STATE OF WASHINGTON
DEPARTMENT OF ECOLOGY

January 24, 2011

Re: Opinion on Proposed Cleanup of the following Site:

- **Site Name:** Streibels Deli Mart
- **Site Address:** 26605 State Road 104 NE, Kingston, WA
- **Facility/Site No.:** 681 981 52
- **VCP Project No.:** NW 2232

Figure 3
 Surrounding Properties

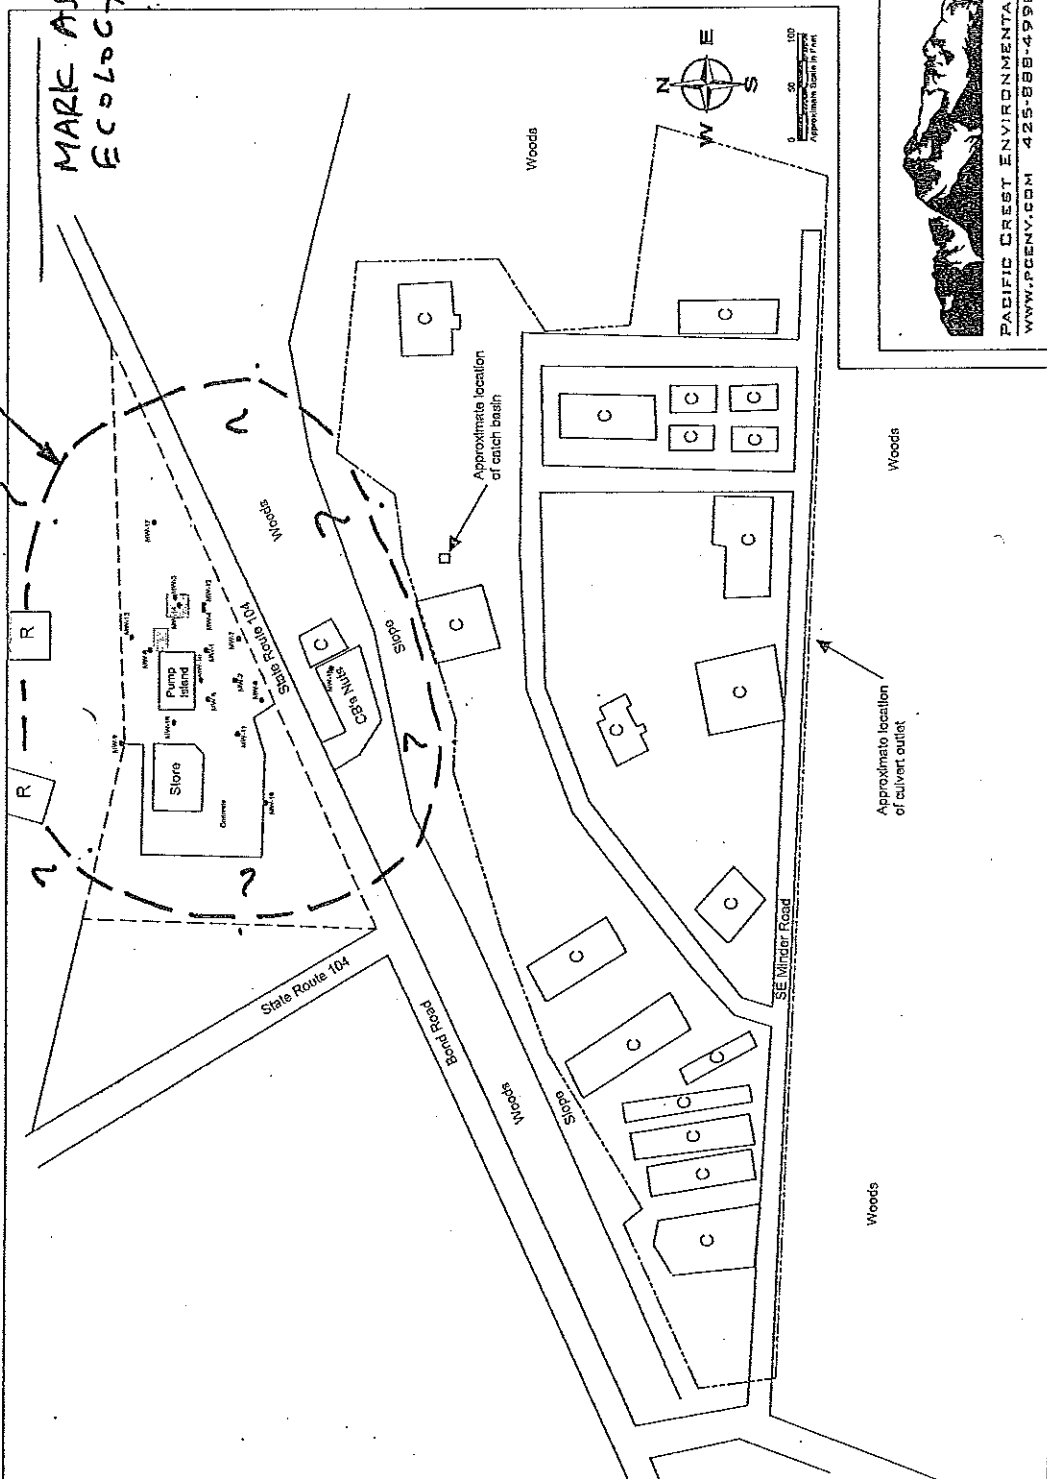
Site: The Site comprises petroleum hydrocarbon releases, primarily gasoline, at the property located at 26605 State Road 104 NE near Kingston in Kitsap County (the Property). An operating convenience store, with retail fuel sales, currently occupies the Property. The Property and the Site are shown on the attached Site Map.

Subsurface soil vapor is migrating laterally within the unsaturated zone, and is venting at land surface. The lateral extent of contaminated soil vapor is not known, but could extend well beyond the boundary of soil and ground water contamination, potentially posing a risk to nearby homes. The closest residence is about 100 feet north of the main area of soil contamination. The vertical extent of soil vapor contamination likely goes no deeper than the lower perched zone, or about 60 feet bgs.
